SPEATH ENGINEERING

RE: Port Pheonix Water Way Marina – DCI2023-00054 – Major PD

Please find below responses and commentary to the provided comments from staff in your September 10, 2024 letter regarding the Commercial Planned Development Application for Port Pheonix Water Way Marina (DCI2023-00054).

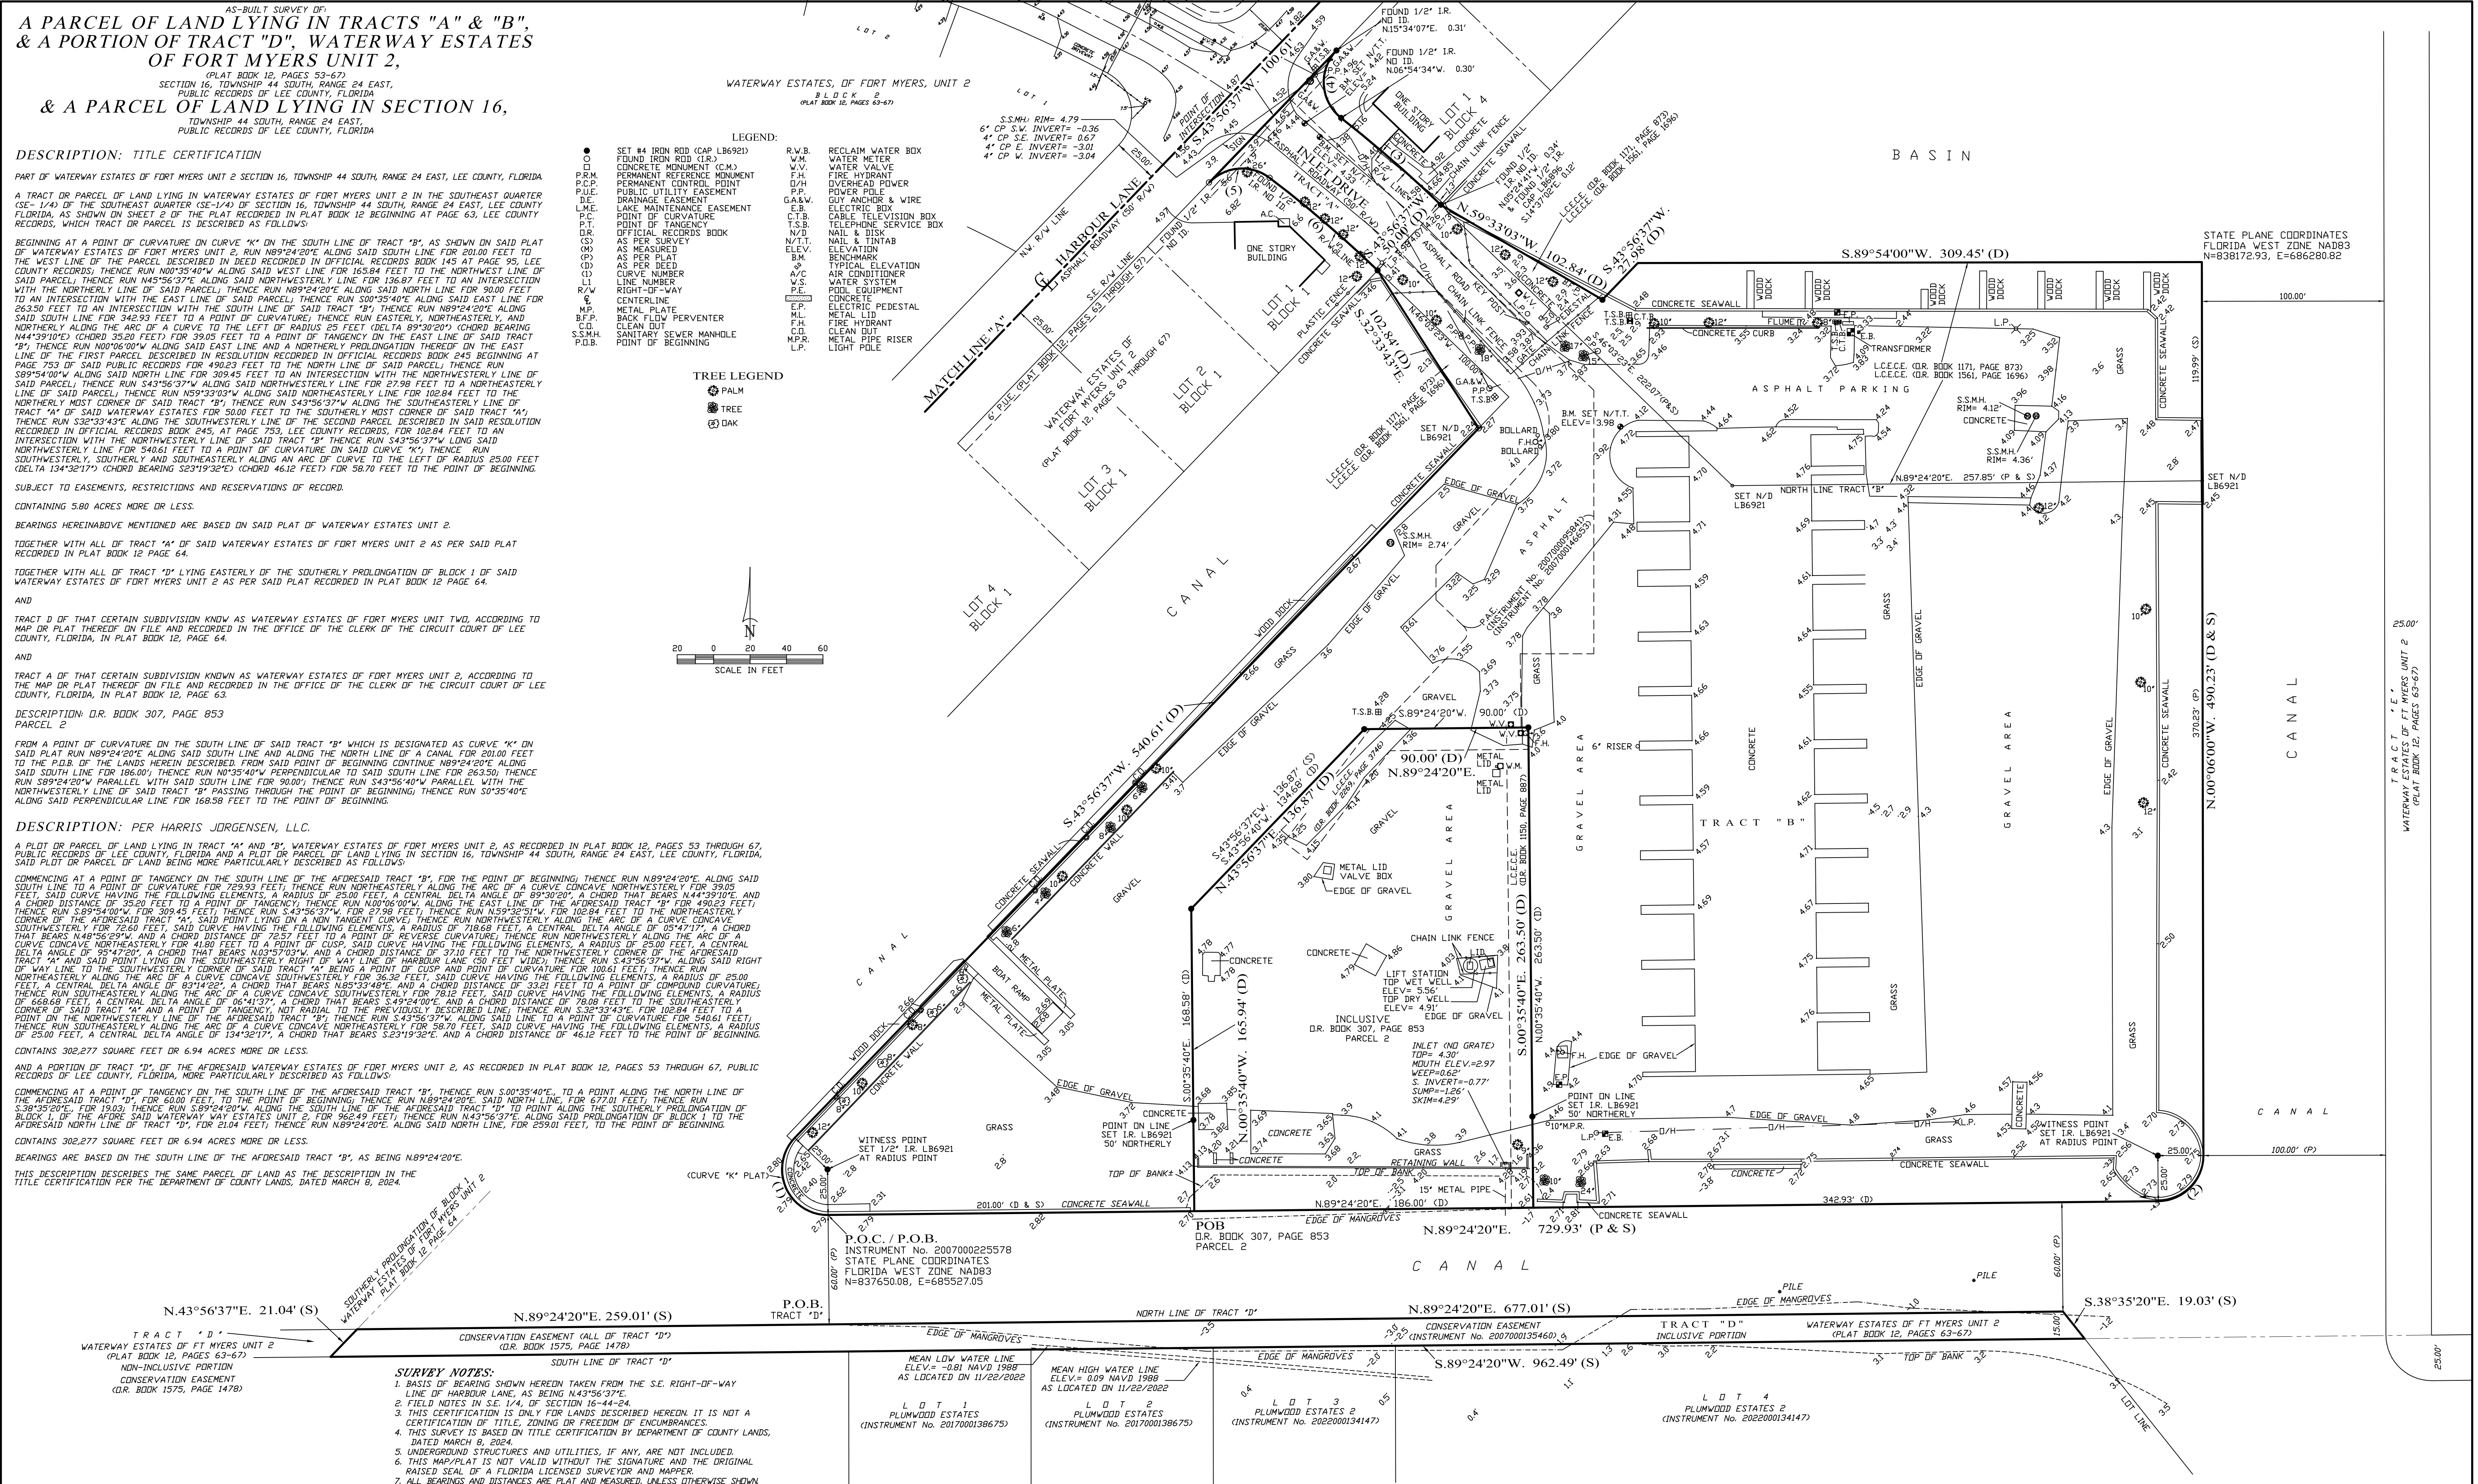
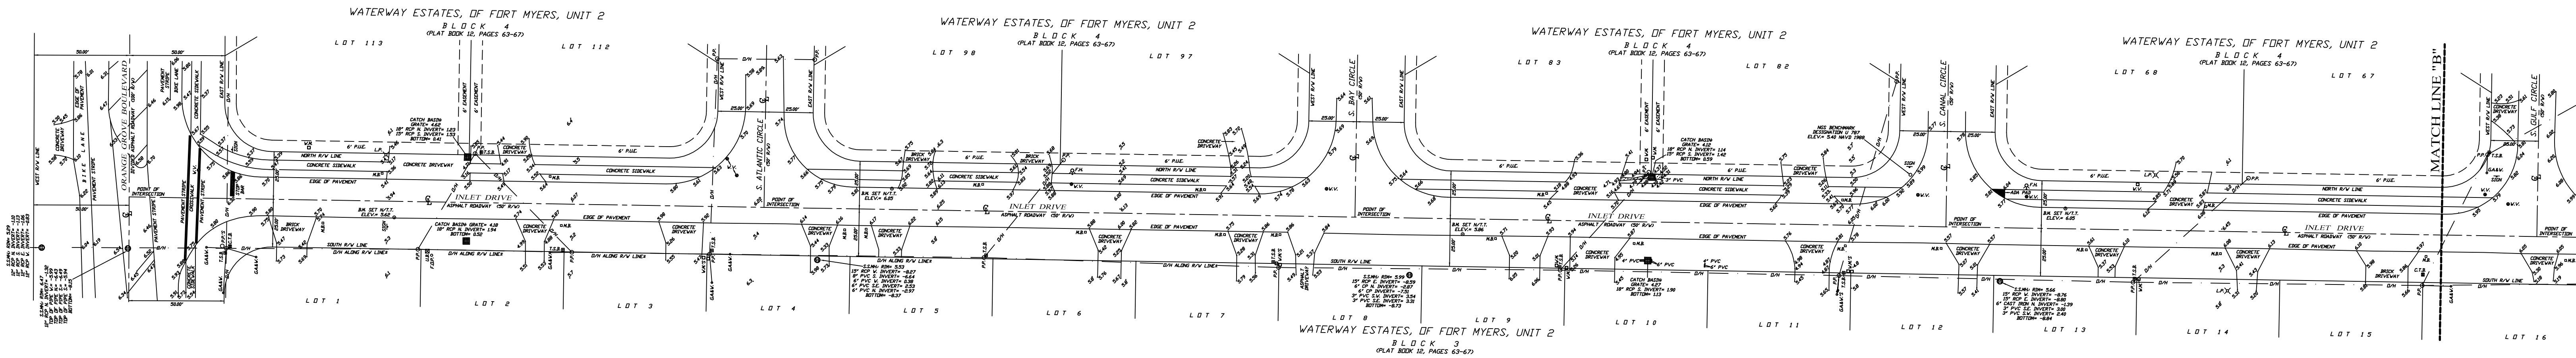
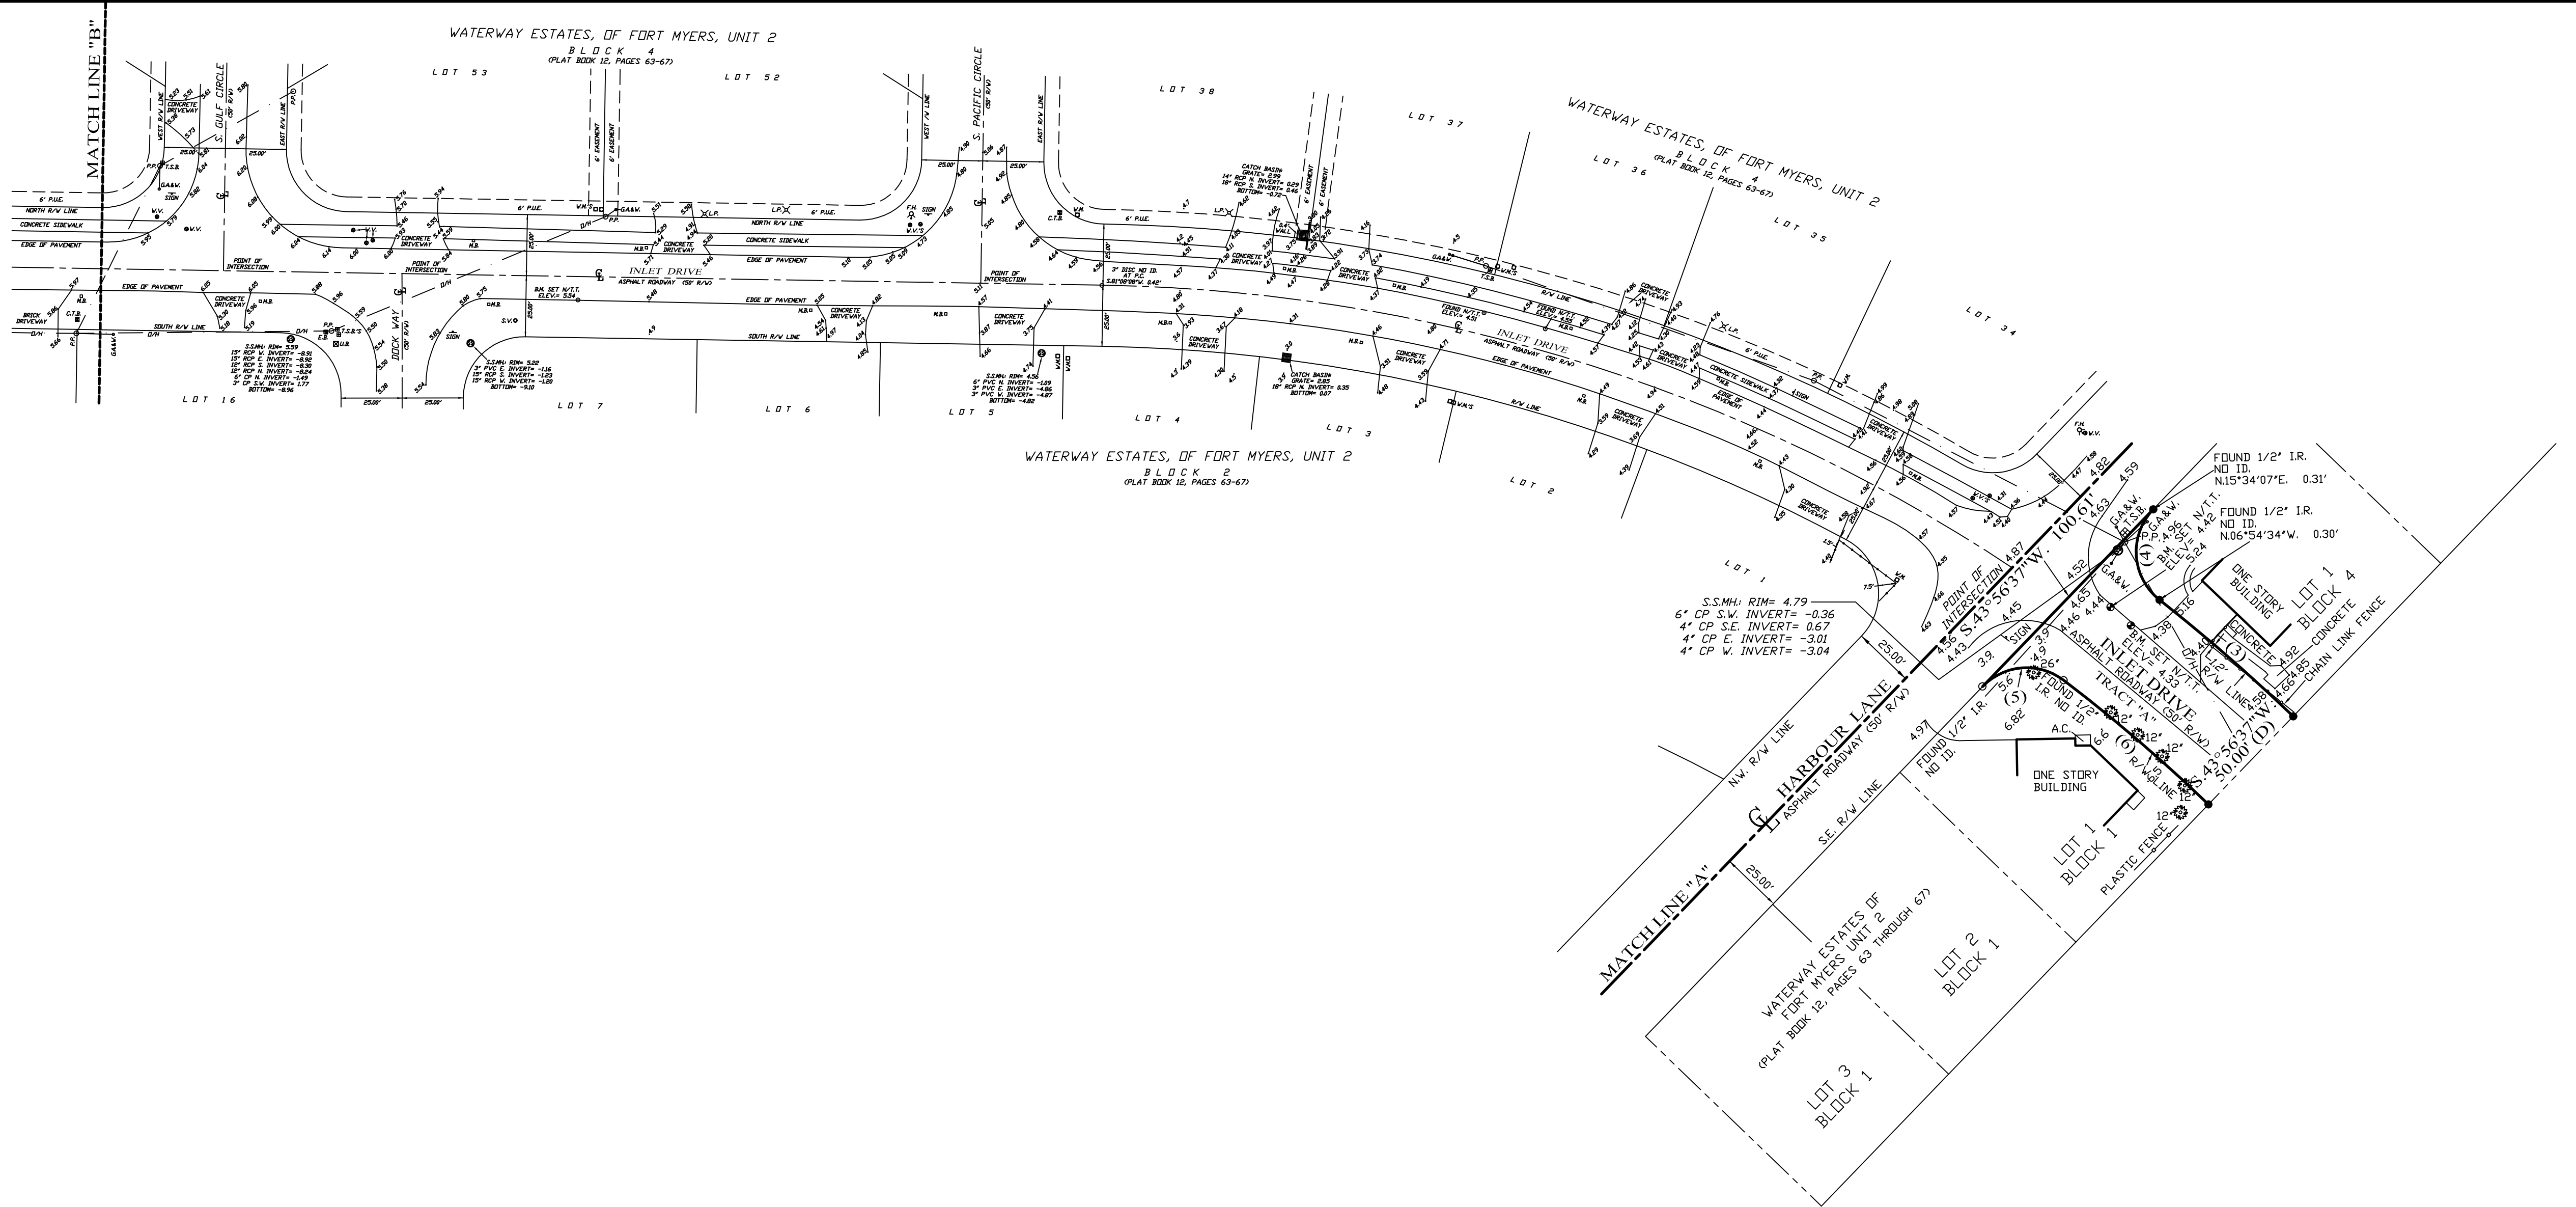
(6) Please provide a boundary survey of the subject property in accordance with the requirements of Lee County LDC §34-202(a)(6). The boundary survey was not revised to include "Tract D" of Waterway Estates Unit 2 PB 12 Pg. 64.

The boundary survey has been revised to include Tract D of Waterway Estates Unit 2 PB 12 Pg. 64. Please see attached updated boundary survey.
